**ADDENDUM NO. 1**

**March 8, 2024**

CEDAR KEY  
SANITARY SEWER  
LIFT STATION  
REHABILITATION

**C4** LIFT STATION 1 VALVE BOX UPGRADE PLAN  
SCALE: 1" = 1.25' 0 0.625' 1.25' 2.5'

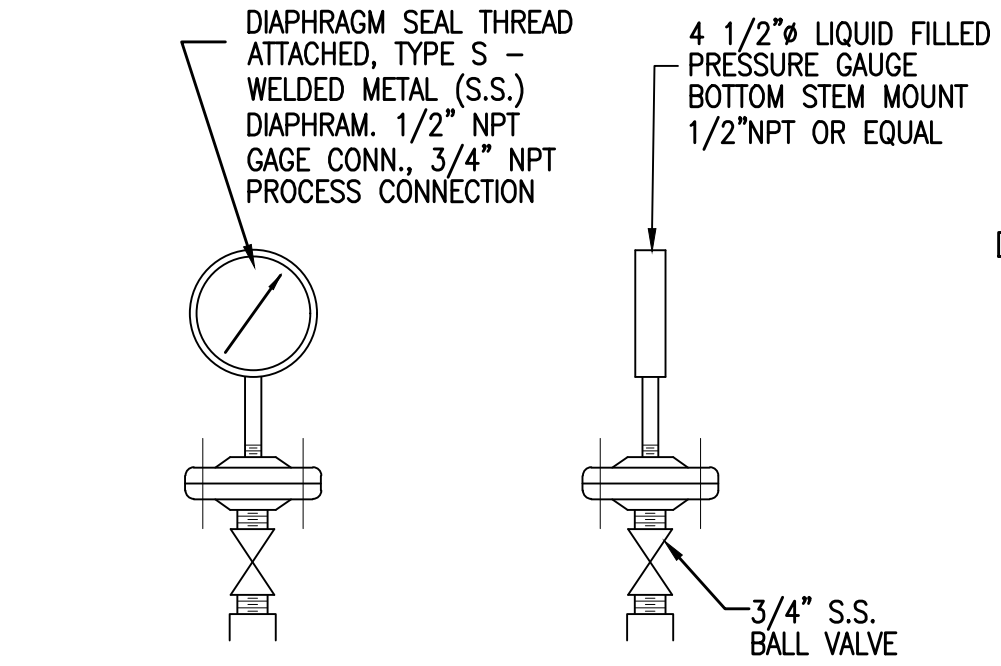
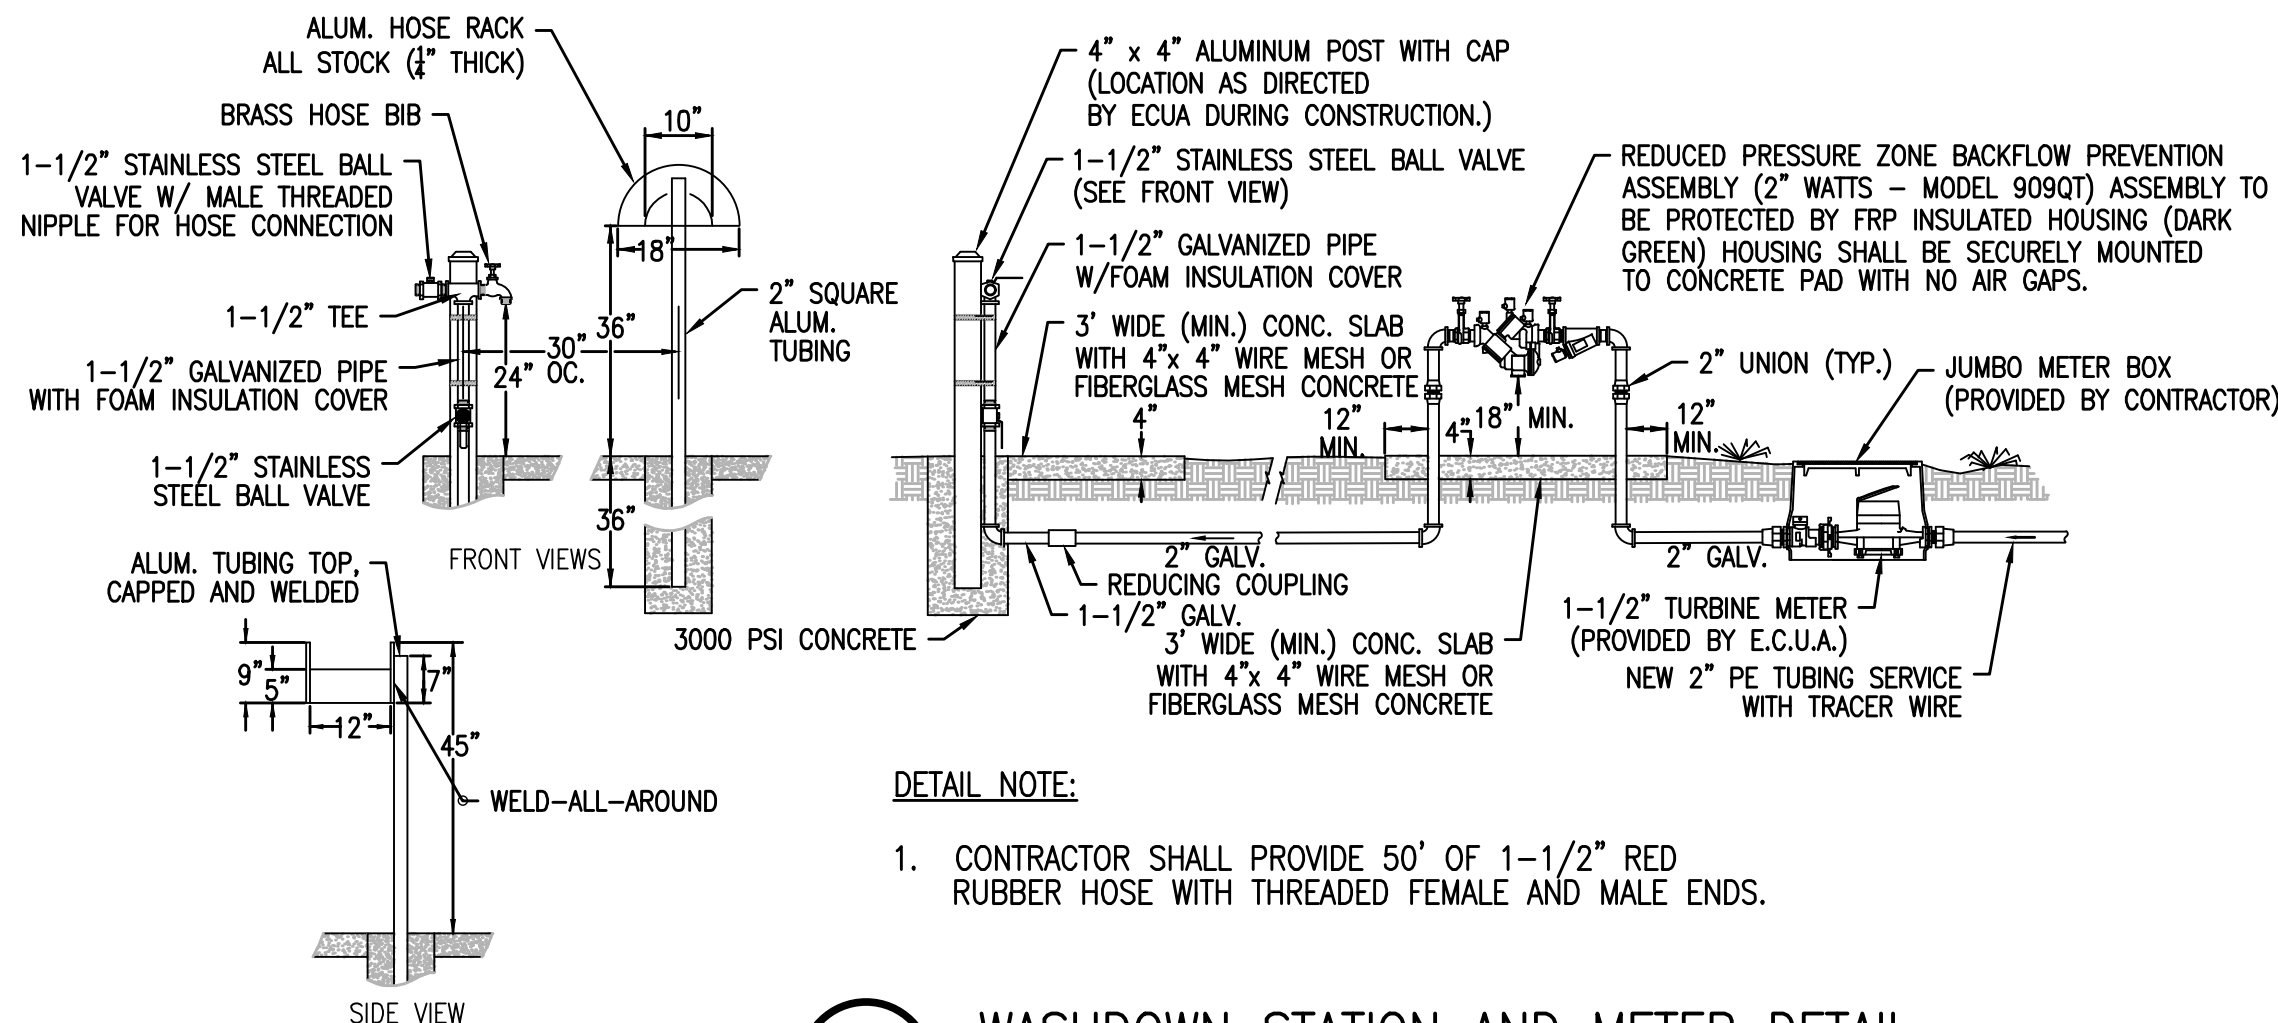
- Q. Please confirm the load rating of the valve box hatch covers for LS1 and LS7 as H-20 for occasional traffic or H-20 for Off Street Truck Traffic.
- A. The hatch for Lift Station 1 shall be 00821624C01 Access Hatch by EJ Group, Inc or Approved Equal. An Approved Equal must meet or exceed the minimum standards of the 00821624C01 Access Hatch by EJ Group, Inc. The hatch for Lift Station7 and the Lift Stat 7 valve box shall be F1H Access Door by Halliday Products or Approved Equal. An Approved Equal must meet or exceed the minimum standards of the F1H Access Door by Halliday Products.
